**ZONING CHANGE REVIEW SHEET**

CASE: C814-89-0003.02 – 305 S. Congress PUD      DISTRICT: 9

TO: PUD-NP, to change conditions of zoning

STREET SECTION B-B'  
BARTON SPRINGS AVENUE TYPICAL SECTION 56' WIDE

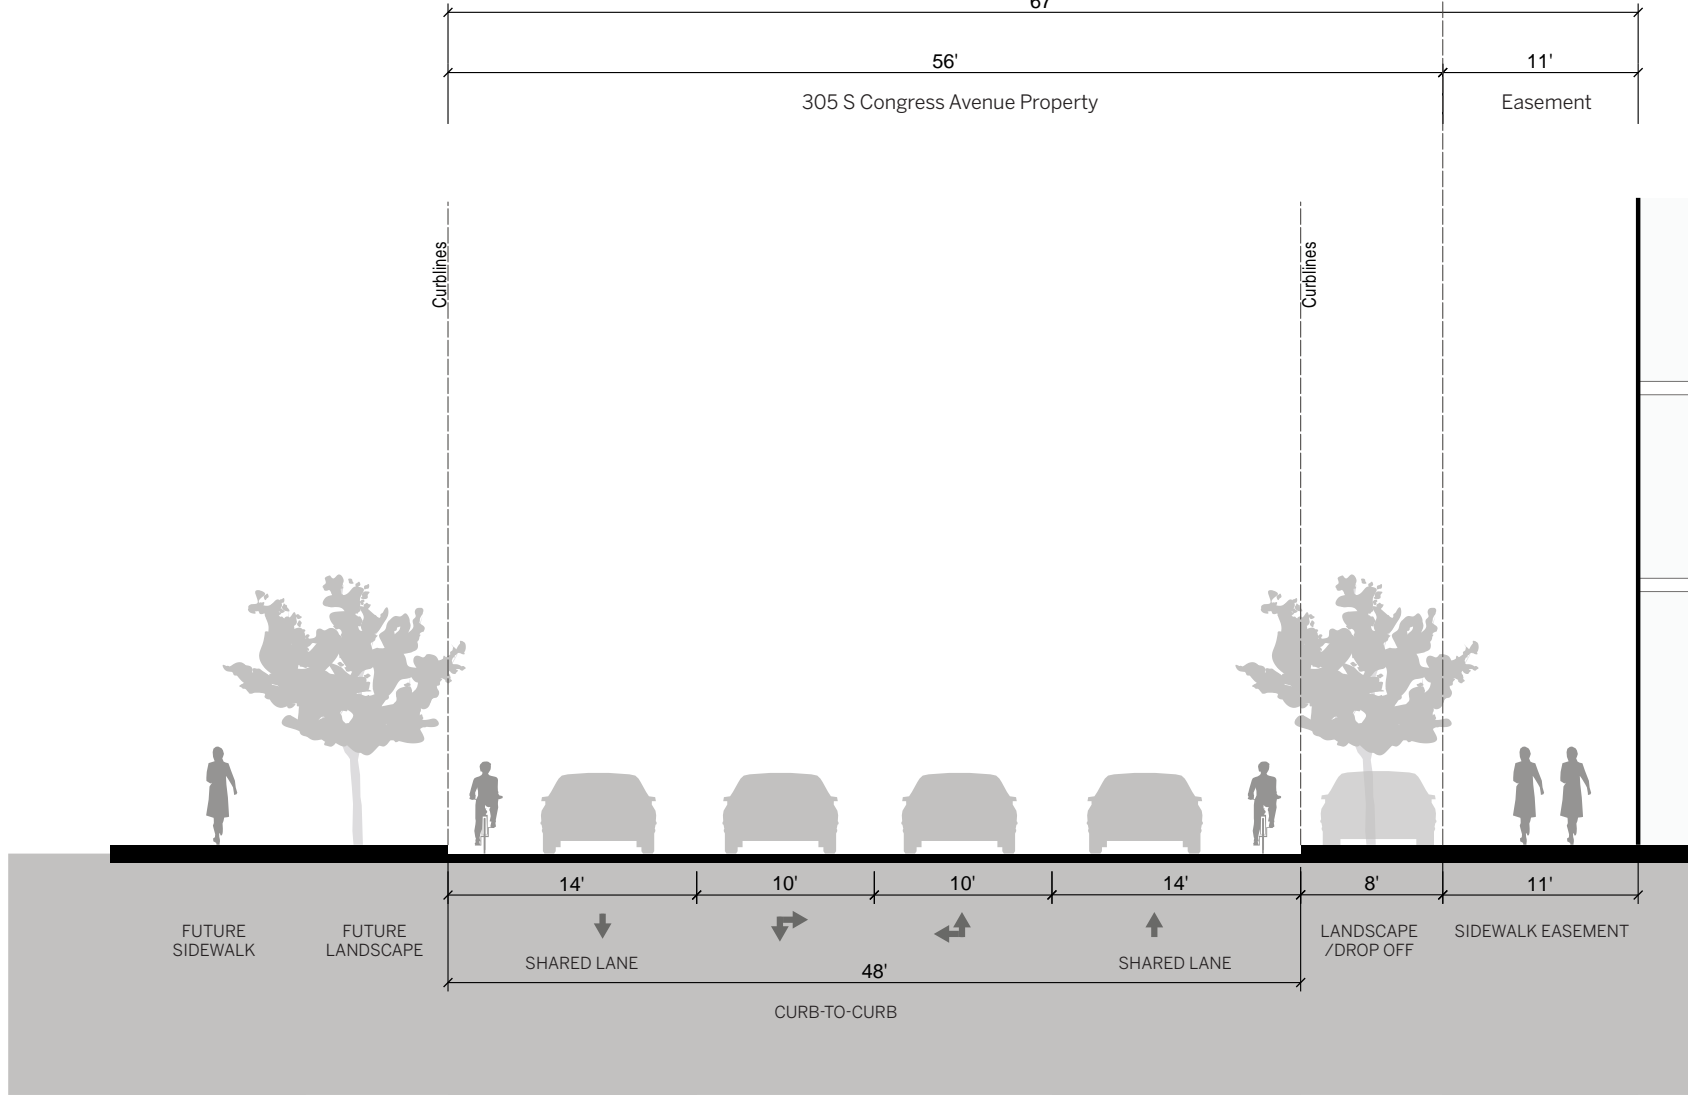
- Barton Springs Road extension shall be considered an Urban Roadway for the purposes of complying with Chapter 25-2, Subchapter E – Design Standards and Mixed Use, and will be designed in accordance with the PUD street sections located on Sheet 4.

- a. Recommended by staff if the PUD cross section (Sheet 4) is amended to reflect four 10' vehicle travel lanes, a 2' raised buffer, followed by an 8' cycle track at minimum, 8' landscape zone and 11' sidewalk at minimum.

PEDESTRIAN WALKWAY TYPICAL SECTION E-E' 45' WIDE

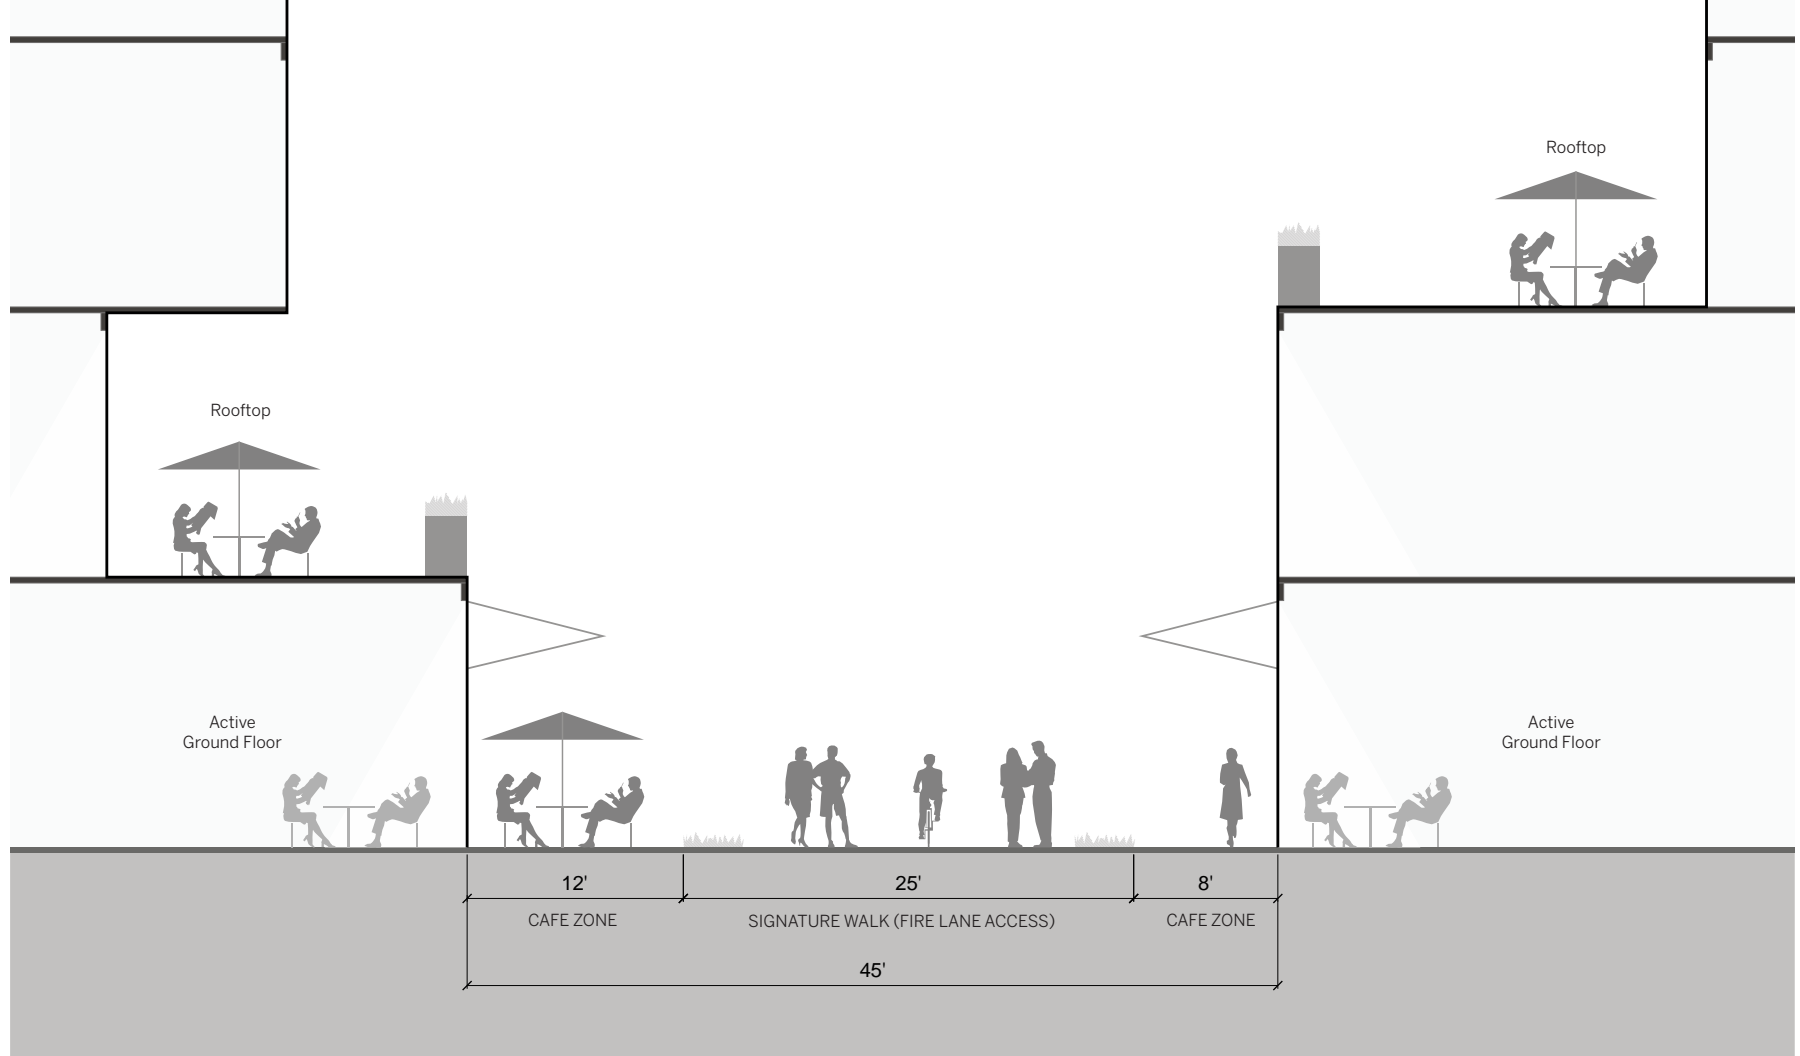
51. Bollards, or another similar type of barrier, will be used to close the Pedestrian Walkway, shown on Sheet 4 as Section E-E, from vehicular traffic.
